ADDENDUM NUMBER 002

Project Number **HPP-3303(419) City Project No. 70232201**
Project Title **MLK Pedestrian Bridge**

ISSUE DATE: **September 25, 2025**

STATE	FEDERAL PROJECT NO. / CITY PROJECT NO.	SHEET NO.
MO	HPP-3303(419) / 70232201	E101

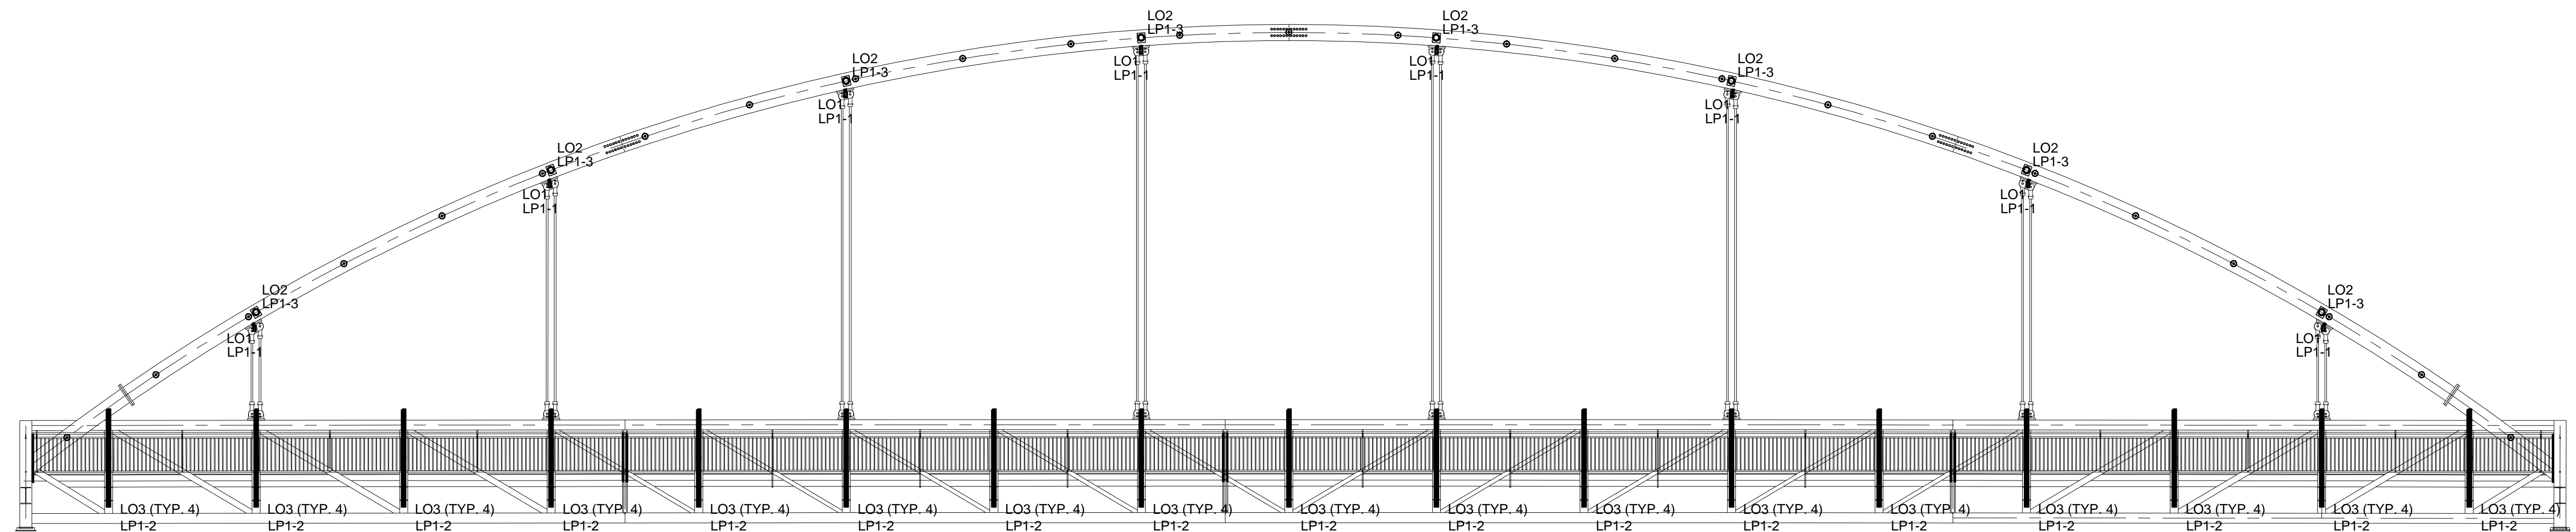
Q19.	Drawing E103 on the Luminaire schedule shows different QTY for L05, and L04. Please confirm QTYS.
A19.	Do not refer to the photometric plans for quantities as not all or adjacent fixtures are utilized in this study.
Q20.	Please provide Pedestrian light pole details and confirm where the 7 luminaire L05s and 4 ATB2 P902 R2 3K are located on the plans.
A20.	Do not refer to the photometric plans for quantities, locations, or specifications.
Q21.	Please clarify how the Junction box shown on Drawing E202 Detail 1 is to be connected to the bridge.
A21.	The box will be mounted to the underside of the bridge structure.

STATE	FEDERAL PROJECT NO. / CITY PROJECT NO.	SHEET NO.
MO	HPP-3303(419) / 70232201	E102

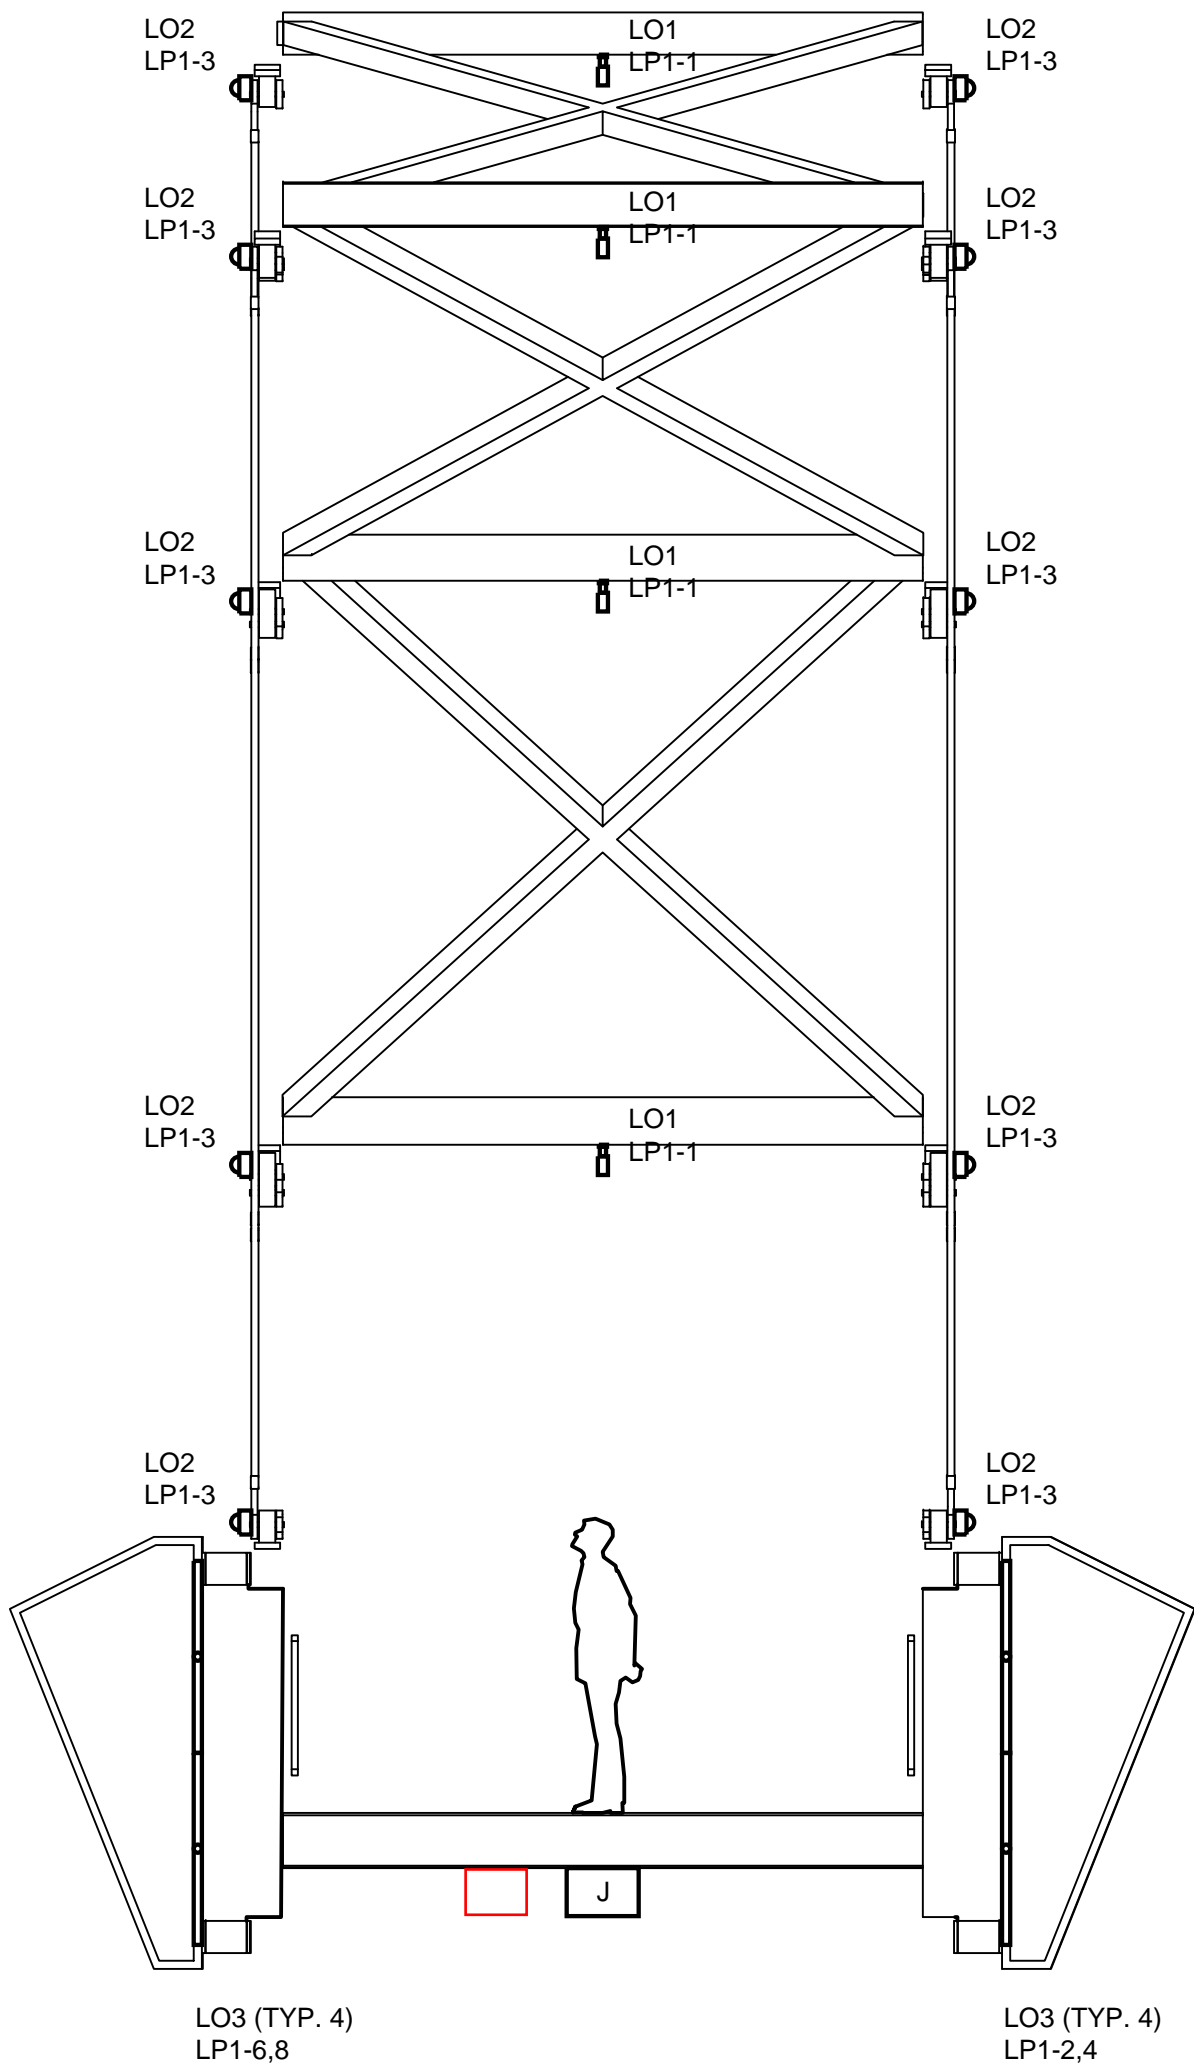
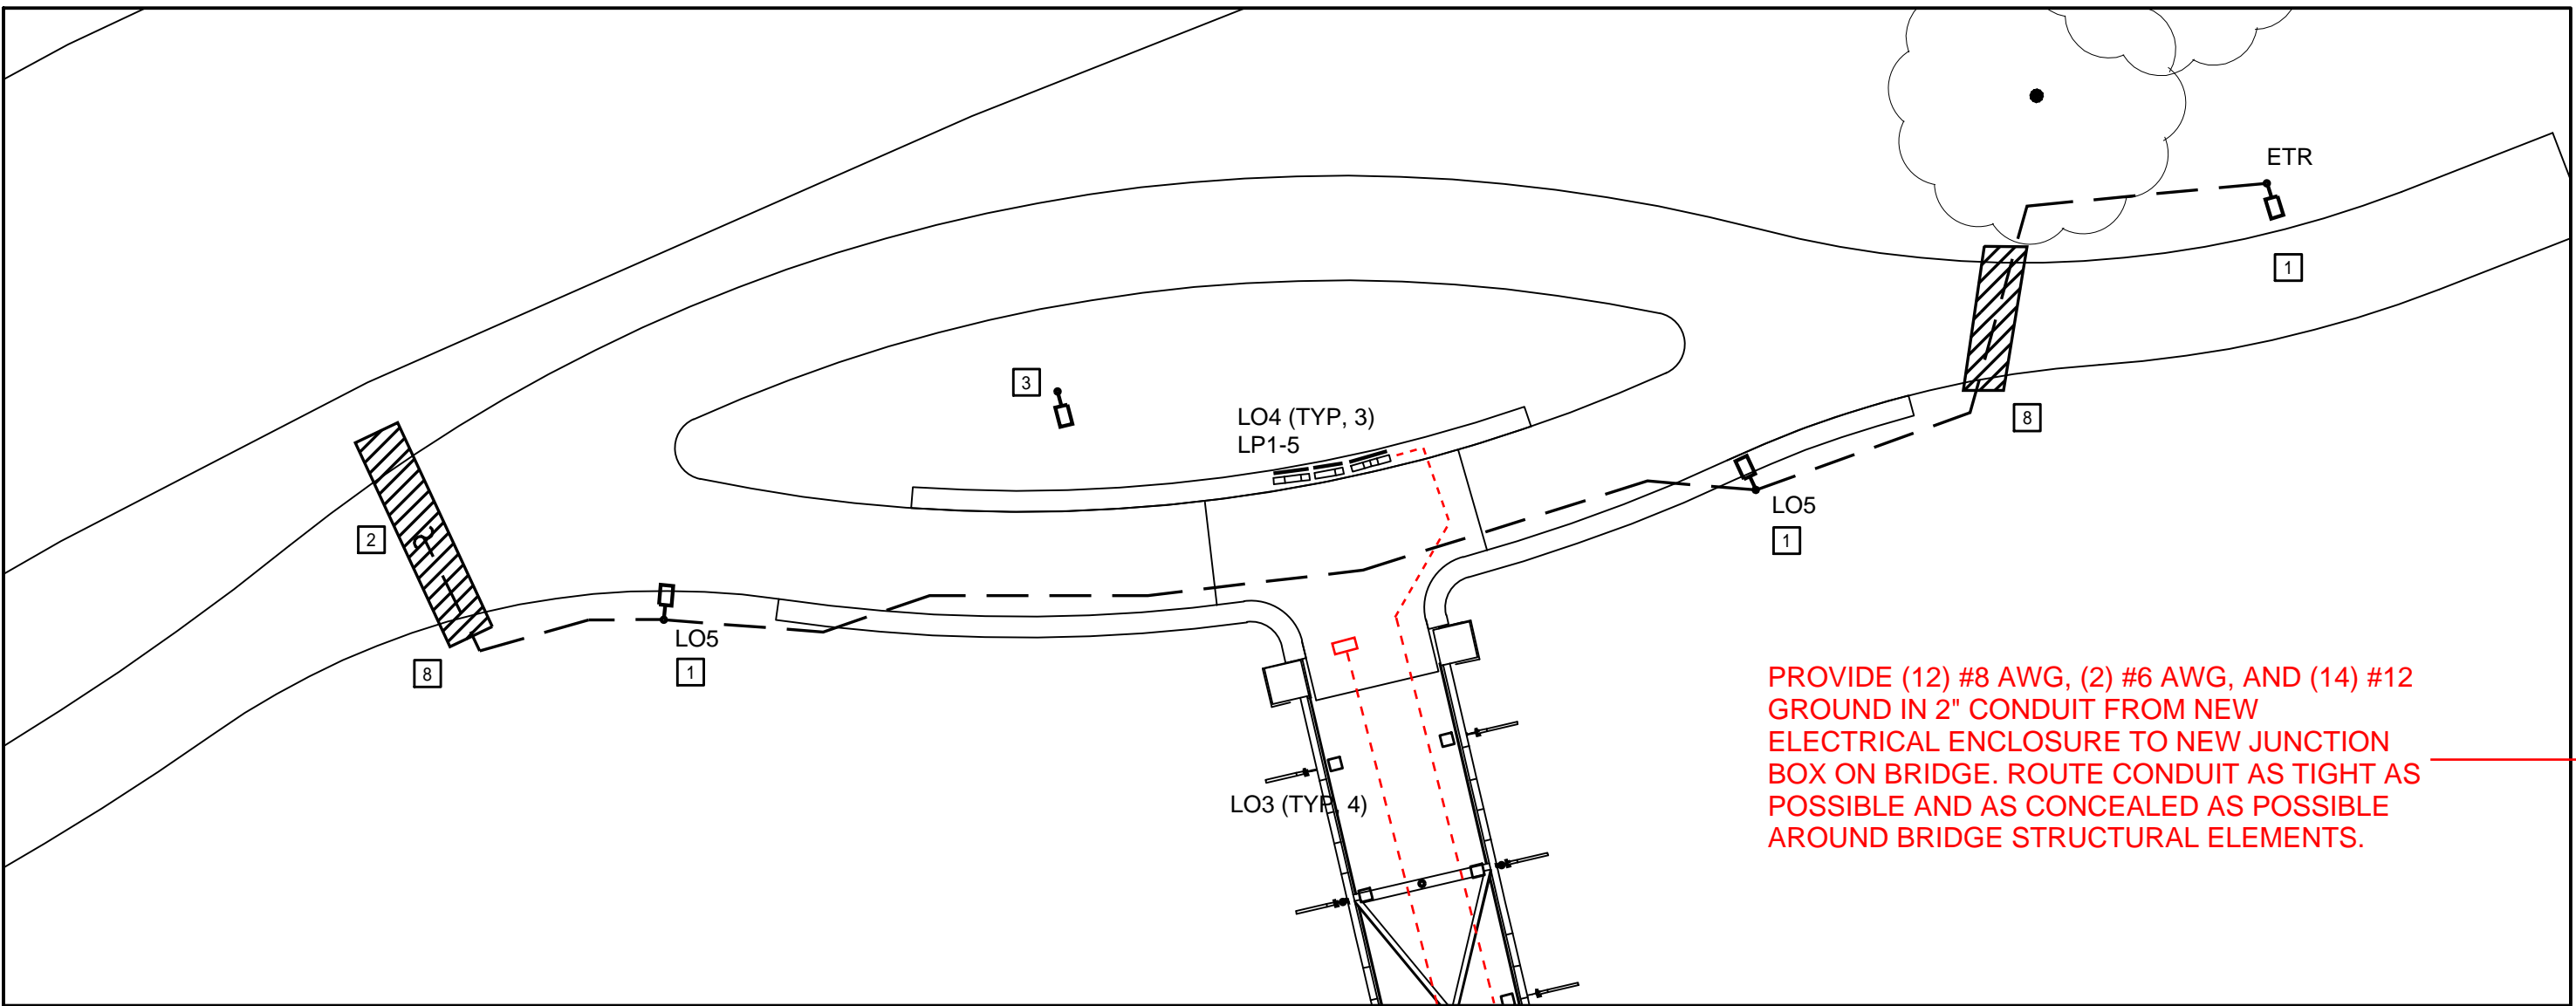
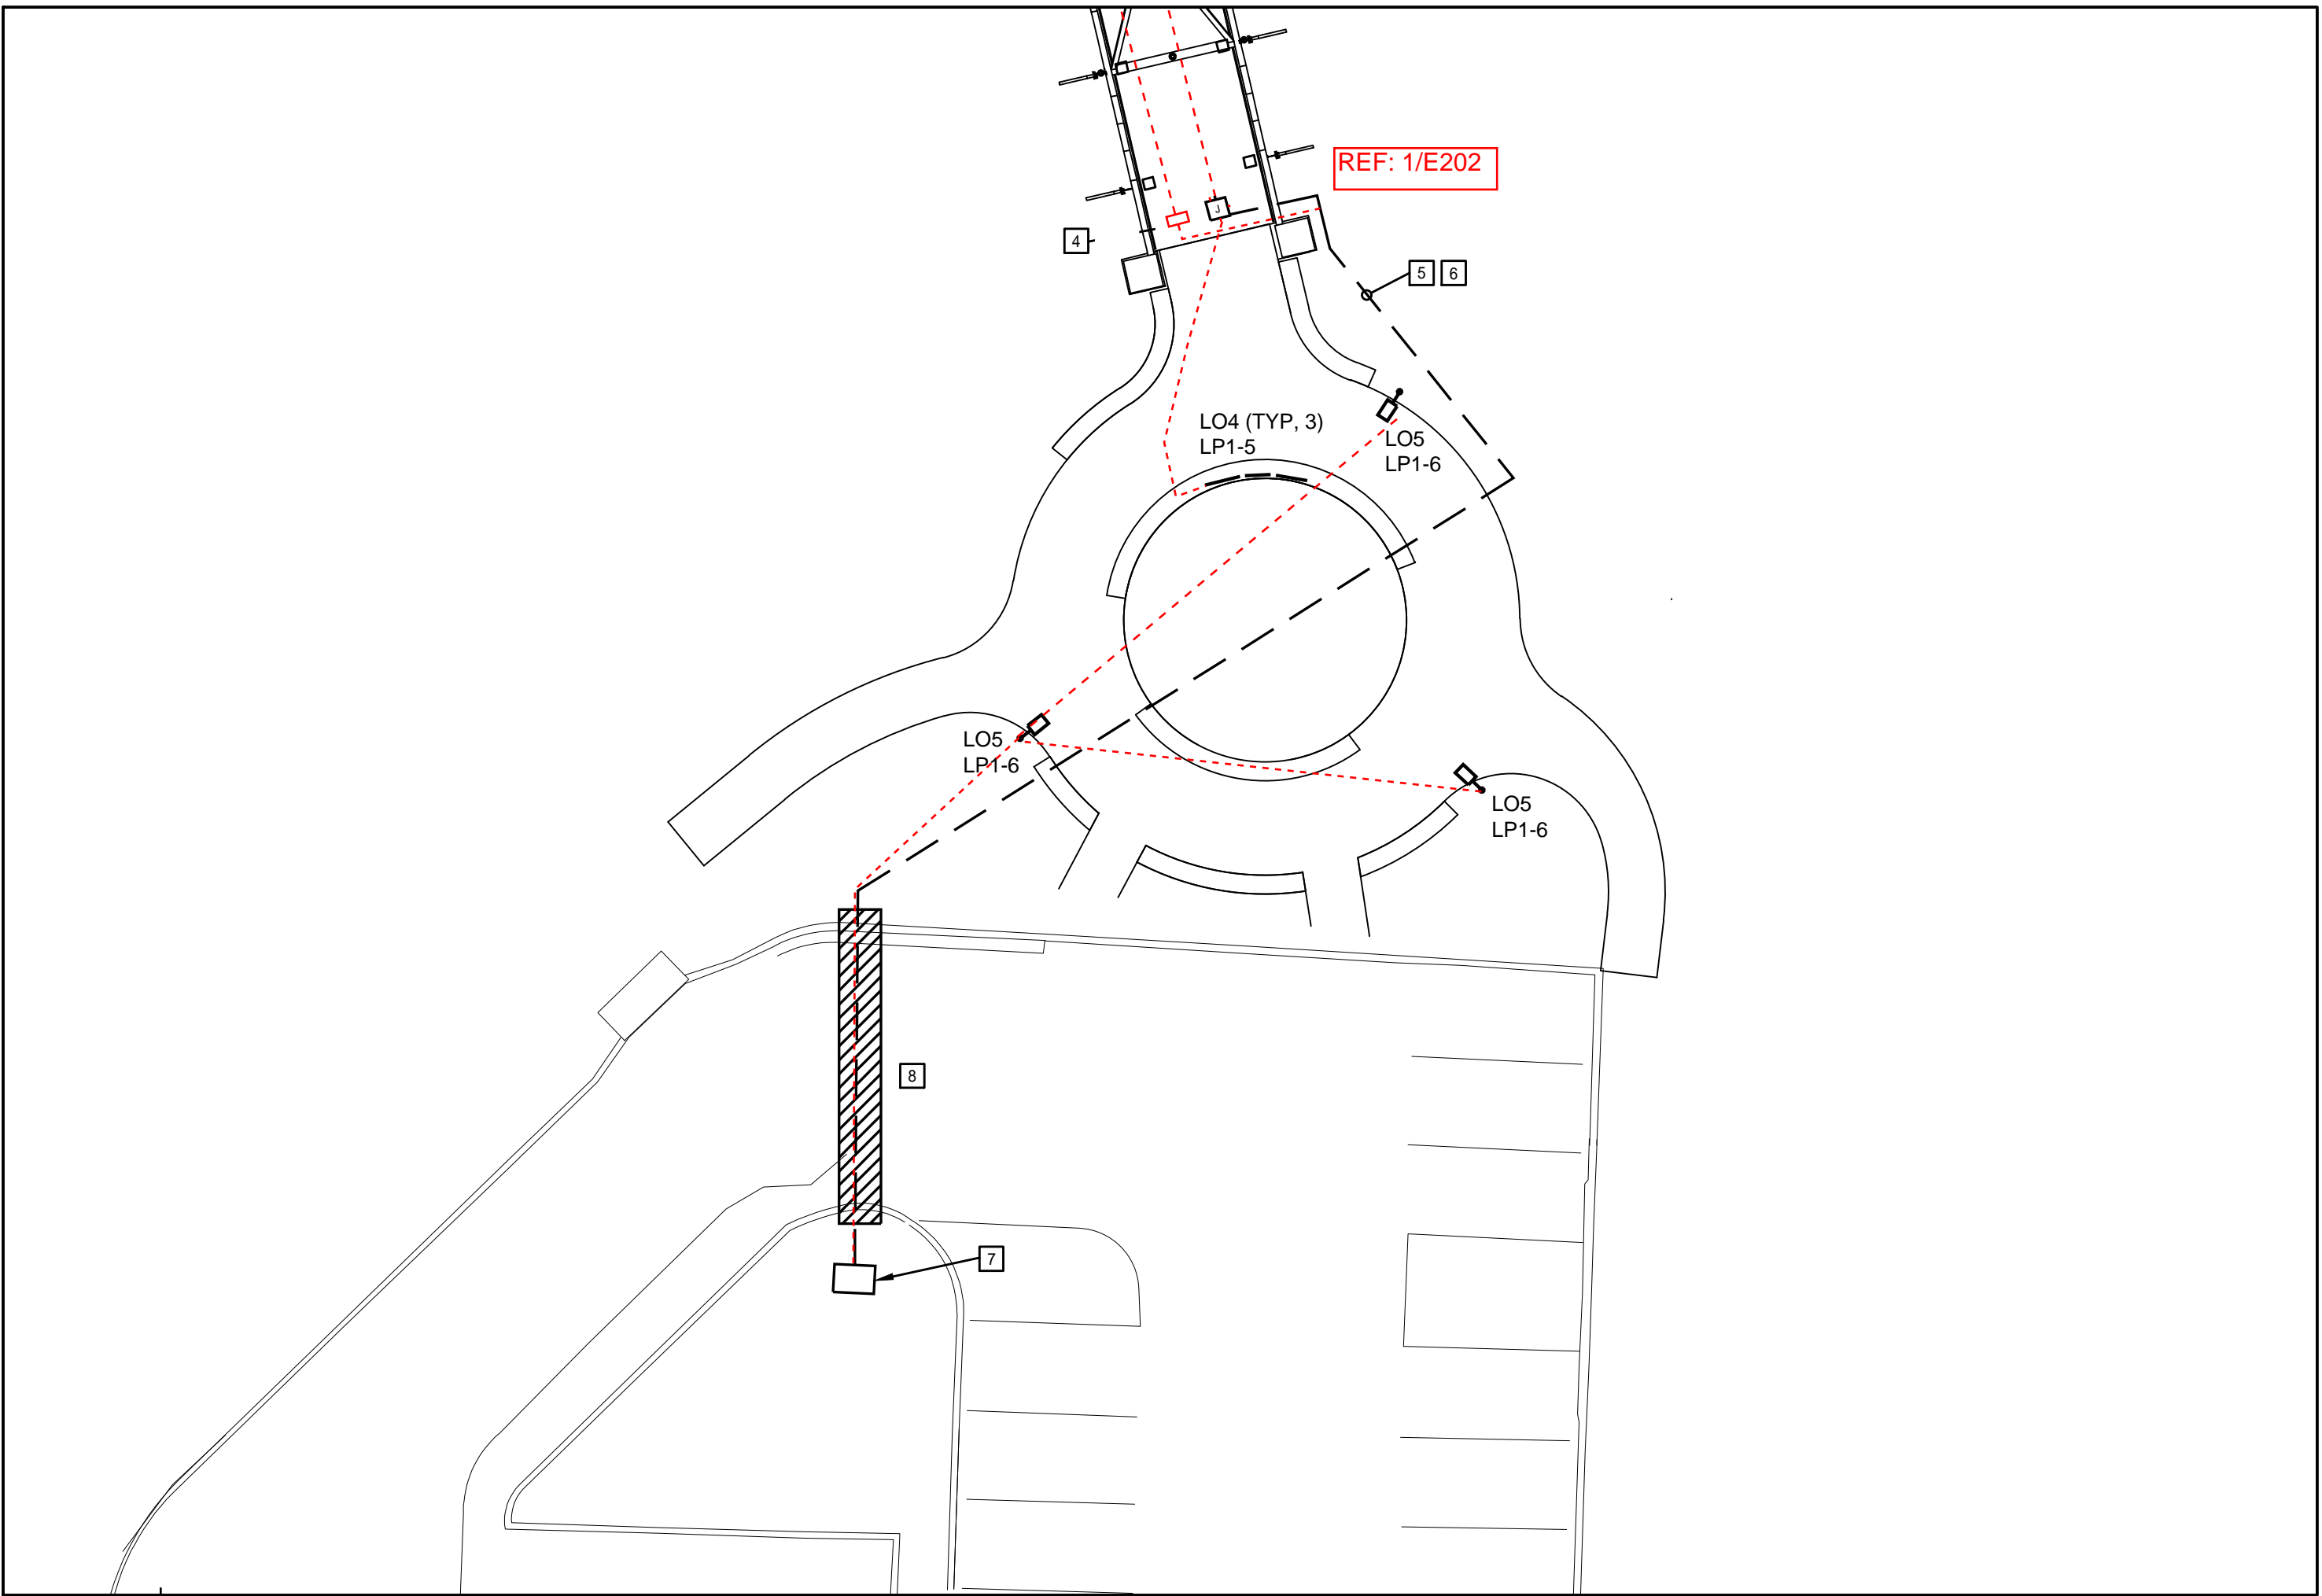
Q4.	Please provide drawings for conduit pathways for how the North and South MLK Signs (L04) are to connect to the new electrical enclosure. Please provide detail on how this pathway crosses the bridge.
A4.	Please refer to attached markups for proposed conduit pathways.
Q5.	Please provide drawings for conduit pathways for the 3 L05 Light poles shown on Drawing E102 detail 3 that are to connect back to the new electrical enclosure.
A5.	Please refer to attached markup on 1/E101 indicating conduit pathway.
Q6.	Please clarify what the wire size is to be on drawing E102 per the Keynote 5 that is not provided.
A6.	Wire size is shown on the panel schedule for individual branch circuits. Refer to revised Keynote 5 on attached markup for combined feeder information.
Q7.	Drawing E201 Detail 1 shows the L01 Mounting detail and calls out cable to be routed
